From: Jim Schuessler, National Semiconductor
 To: San Jose Working Group

This is only a "temporary" working group document; I don't propose it have an X3T9.2 document number.

Synchronous Timing Parameters
Linear Transition from SCSI-1 to Fast SCSI

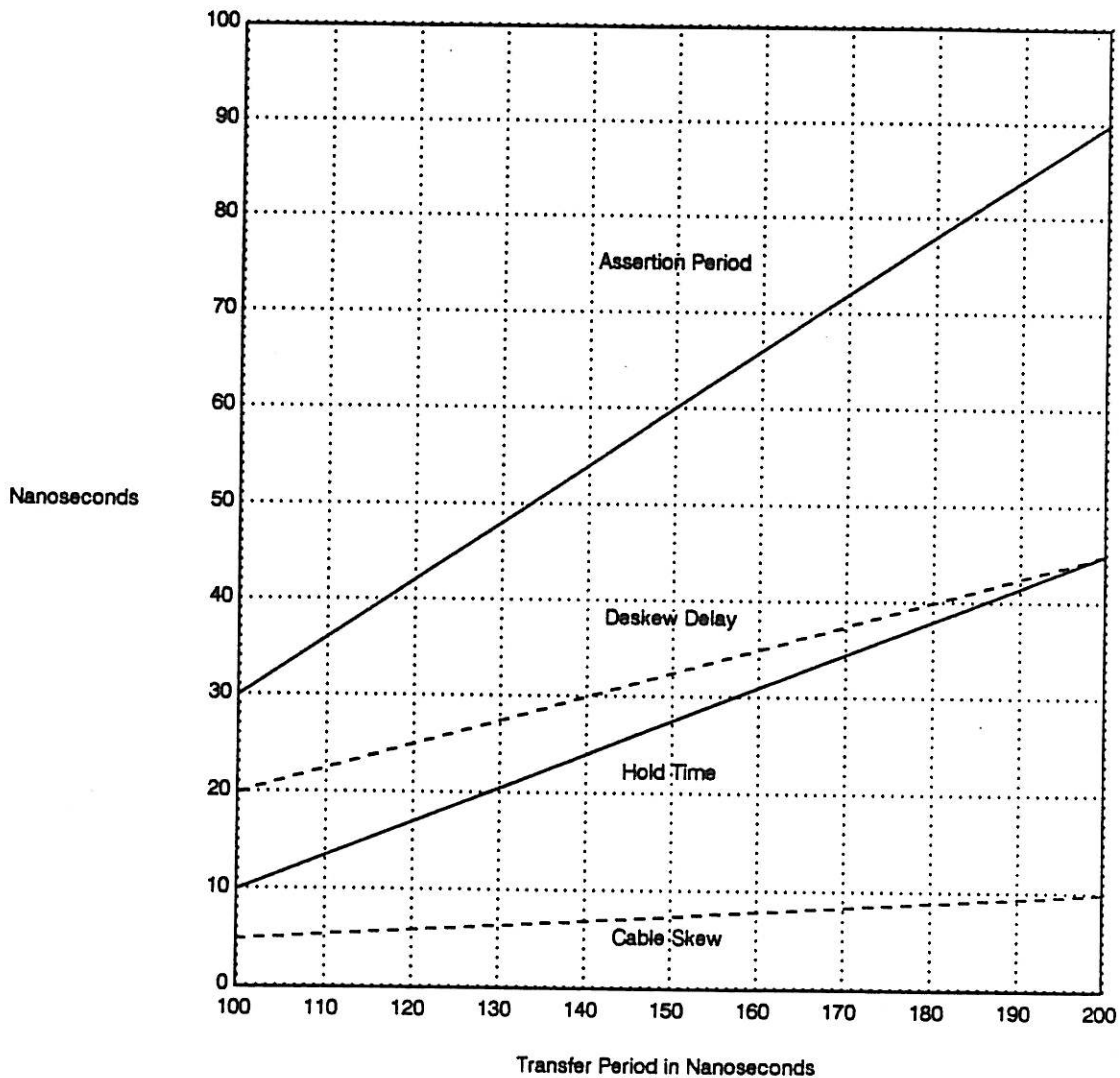
I have taken a second look at Assertion/Negation times as suggested by NCR. After talking with National's engineers, we believe reducing this value from 45nS to 30nS would make designing future protocol chip easier and not degrade performance at all. I am negotiable on reducing it 5nS further to 25nS, although we prefer 30nS.

Document #195 stands now as Rev. 1 with the ammendments shown. I still recomend the linear transition between old and new parameters as the best way to squeeze the most performance out of future chips. Below is a graph which could be used to look up needed timing parameters for fast synchronous mode.
